**CITY OF TORONTO
JEFFERSON COUNTY, OHIO**

WALTON ACRES PHASE 2 – WATERLINE AND STREETScape IMPROVEMENTS

ADDENDUM #2

THRASHER PROJECT #T10-11198

SHEET No.	1
-----------	---

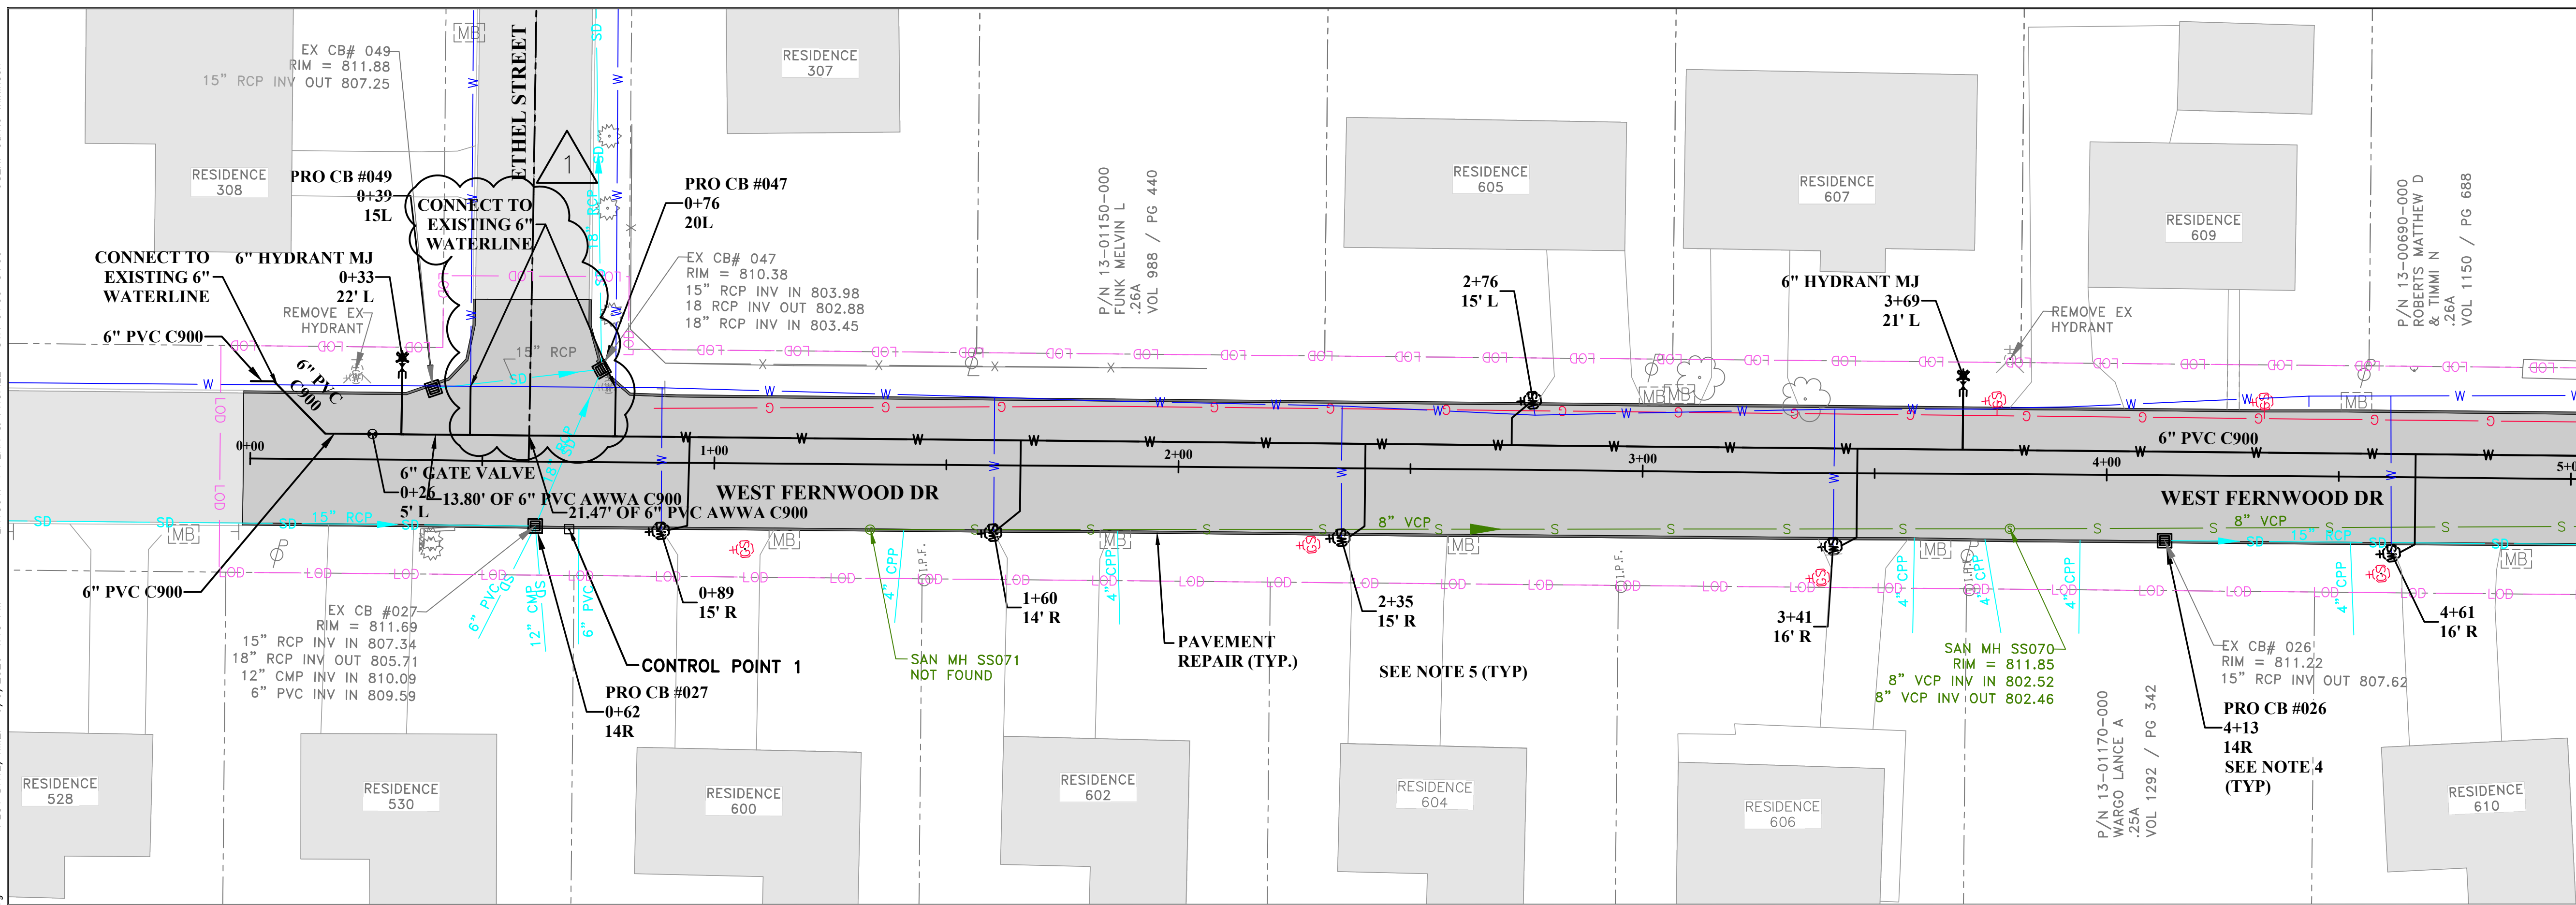
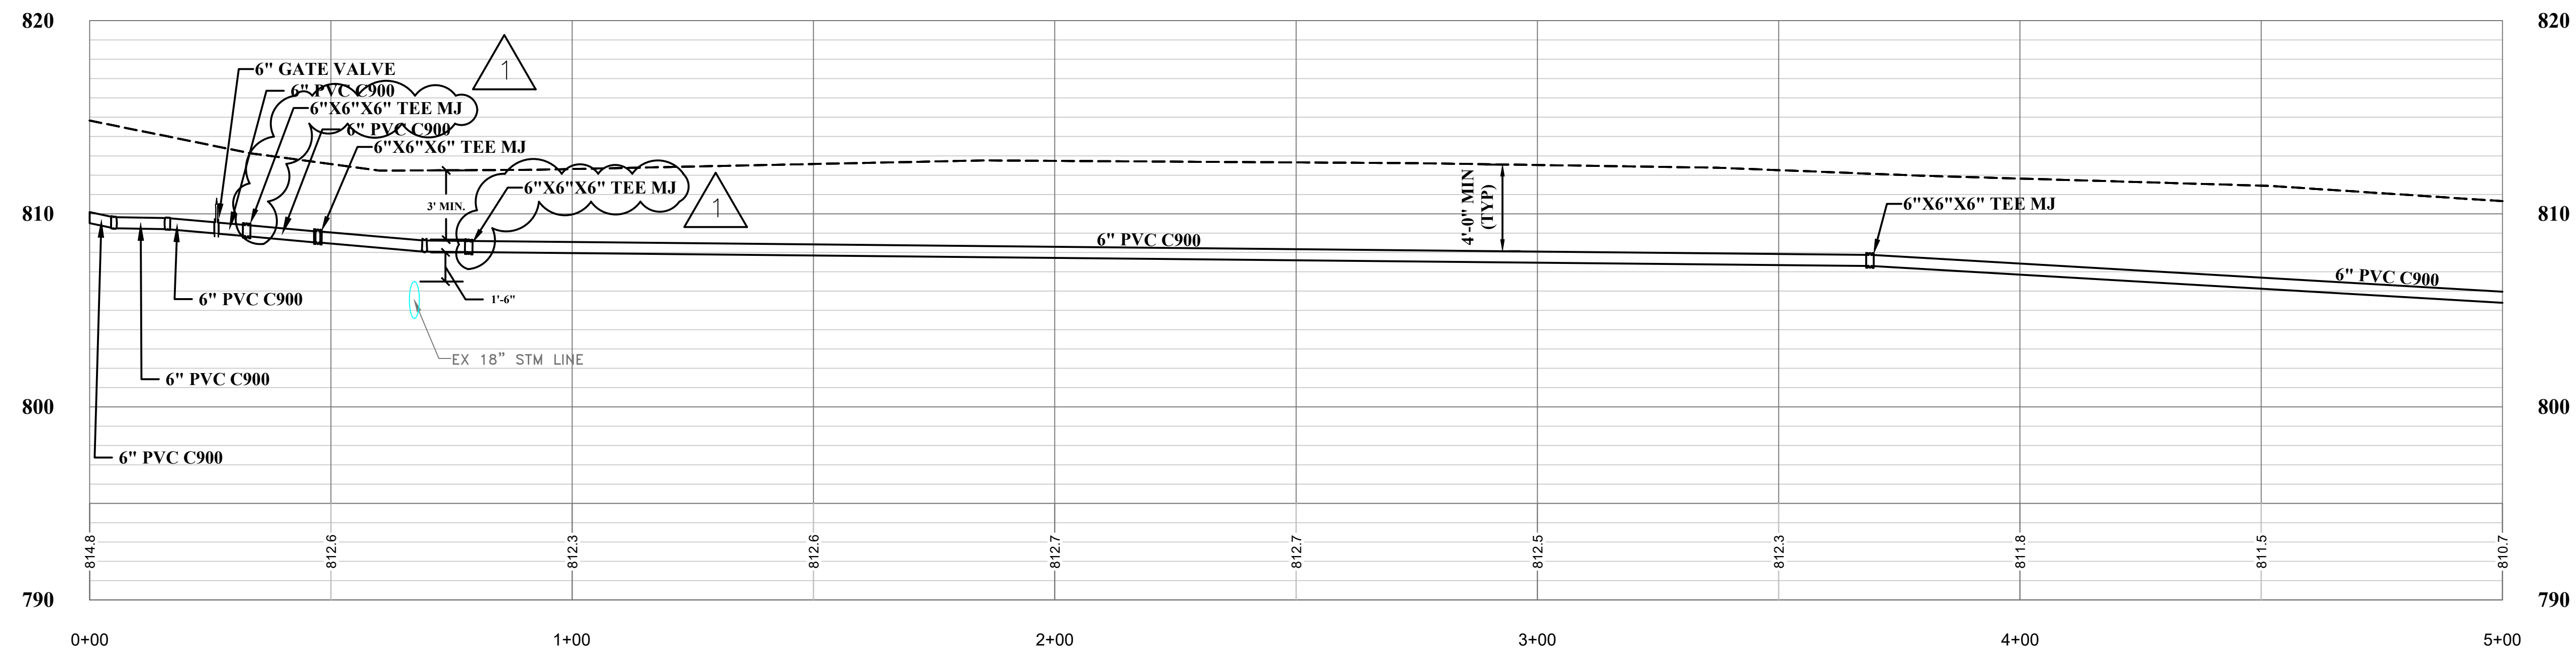
5. For bid item #20 “Connection to Exist. 6” (5 ea) there are only (2) shown on plans at each end of the 6” main. Where are the other (3), and can details for each tie-in be given?

12. Regarding Bid Item 20, “Connect to Existing Water Line”. Proposal Form lists a quantity of 5 Each, we can only find 2, one on page 1 and 1 on page 4.
- i. Are Ethel and Carol Streets to be connected to the new water main?
 - ii. Would you provide clarification on this item?

The additional tie-ins are located along Caroll St and Ethel St, and each street has two connections, totaling 6 connections, the details for the connections are as determined necessary in the field and approved by the engineer. The plans and Bid Form have been updated.

SHEET No.	2
-----------	----------

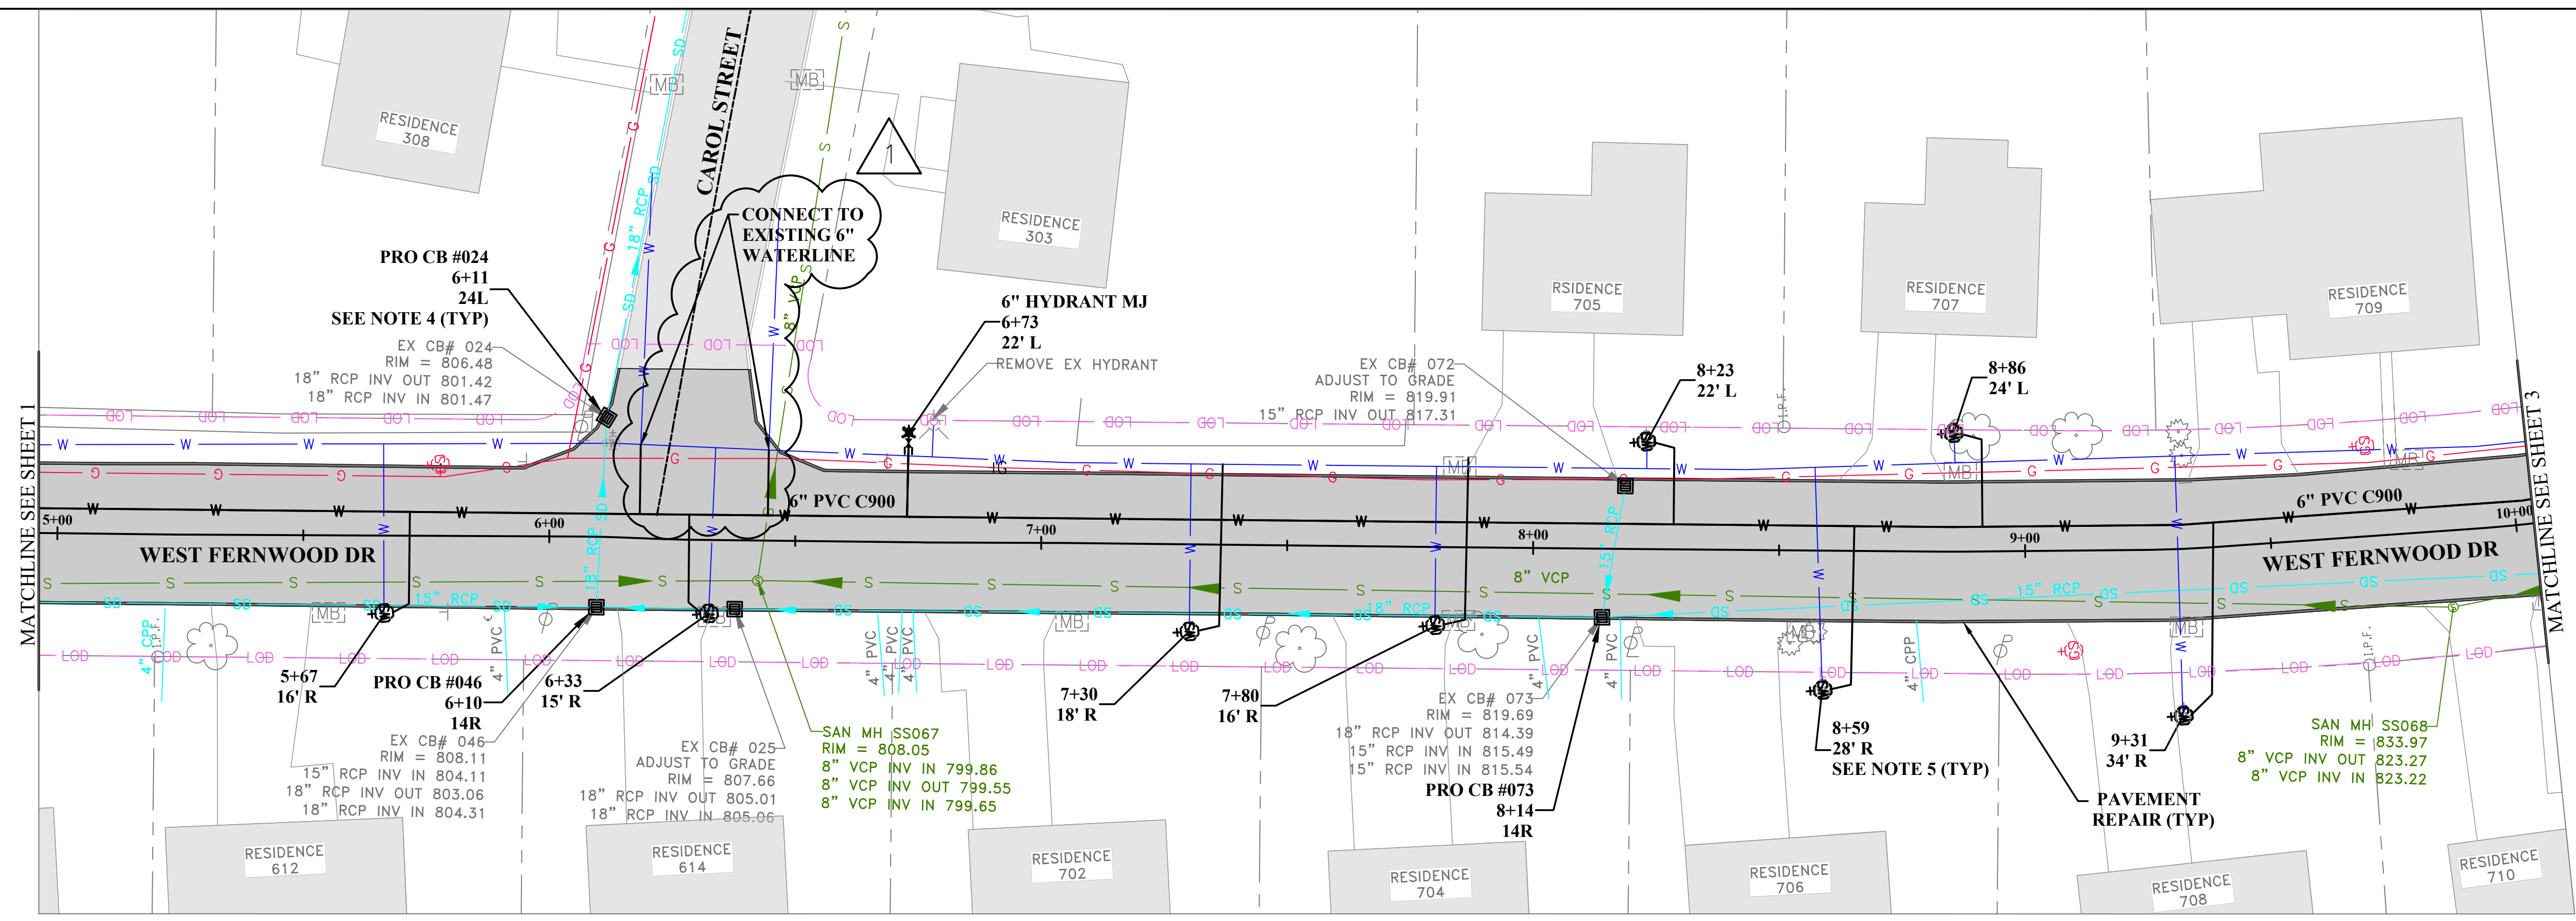
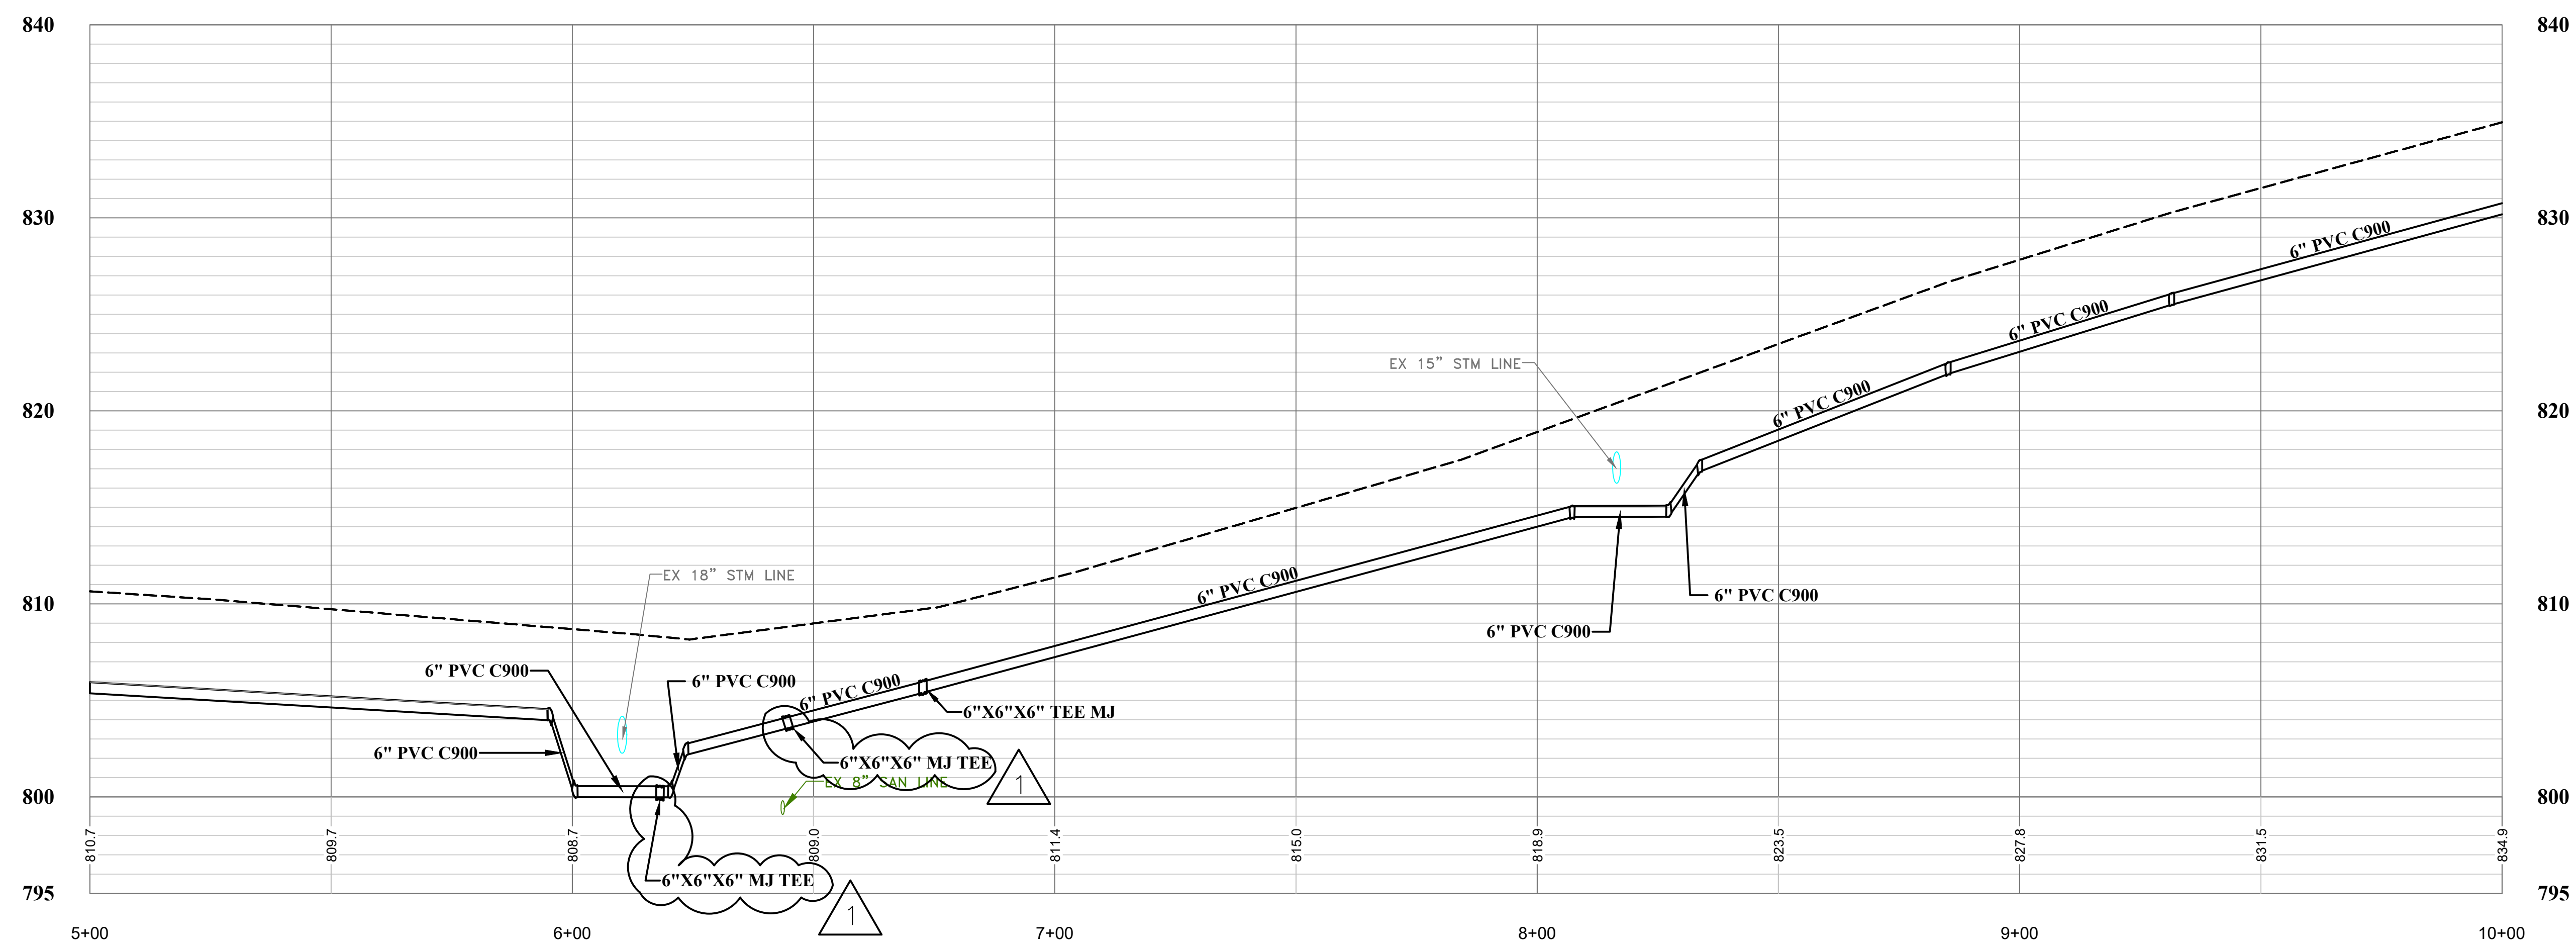
14. Regarding Plan Page 2, the drawing appears to indicate service lines from House No.702 to House No. 303 (station 7+30) and from House No. 704 to House No.705 (station 7+80).

- a. Is this a CAD error?

Proposed water service shown at approximate station 7+30 shall extend east from the curb box shown at House No. 702 and terminate at the proposed connection to the new 6" PVC water main. Proposed water service shown at approximate station 7+80 shall extend east from the curb box shown at House No.704 and terminate at the proposed connection to the new 6" PVC water main.
